Technical Service Bulletin

Topic	Owner's Handbook - Incorrect roof console image shown - Garage Door Opener (GDO)
Market area	Bentley: worldwide (2WBE)
Brand	Bentley
Transaction No.	2062075/2
Level	EH
Status	Released for publishing

Bentayga - W12 and V8 Kovomo only

Figure 1

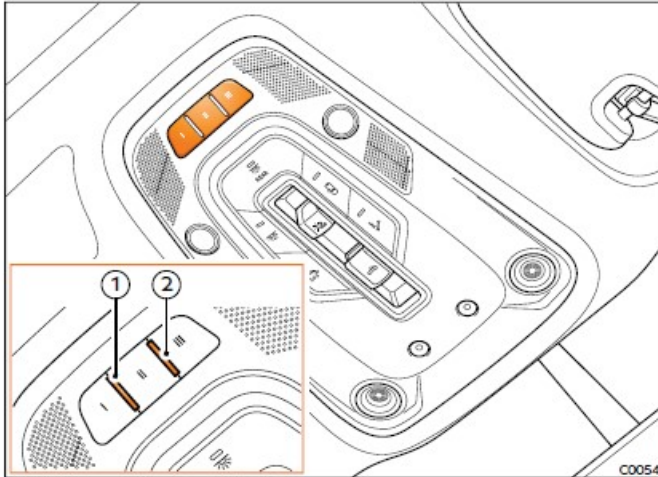
The Owner's Handbook is showing an incorrect roof console image, highlighting the Garage Door Opener (GDO) programming switches for Bentleyga 21MY vehicle derivatives

The image shown in Figure 1 has been removed from the Controls and Interior Features chapter of the Owner's Handbook

□ **The GDO switches are no longer fitted in the roof console and all functionality is controlled within the Infotainment system.**

The configuring of the Garage Door Opener can be now achieved by accessing the following area of the Infotainment system and by following on-screen guidance:

- **Setting and service - Garage door opener - (when fitted)** configure the garage door opener
